**CONDITION OF CONCERN**

**OUTLINE OF REPAIR**

**SUBJECT VEHICLES**

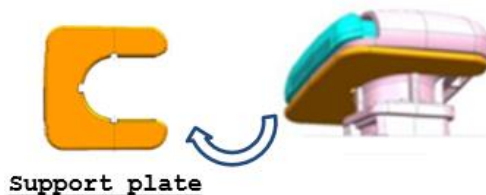
On certain subject vehicles, due to improper installation of the seat cover material of the front driver and passenger seatbacks, the material may interfere with the head restraint lock release button, causing the button to be stuck in the release position. In this condition, the head restraint can be moved freely, without the ability to lock the vertical height adjustment at a desired position.

Install plastic support plates at the bottom of the lock release buttons on both front seat head restraints to prevent the seat cover material from interfering with the lock release button.

Note: Some vehicles may have the support plate on one side (driver or passenger side). If this is the case, install a support plate on the other side (no support plate) only.
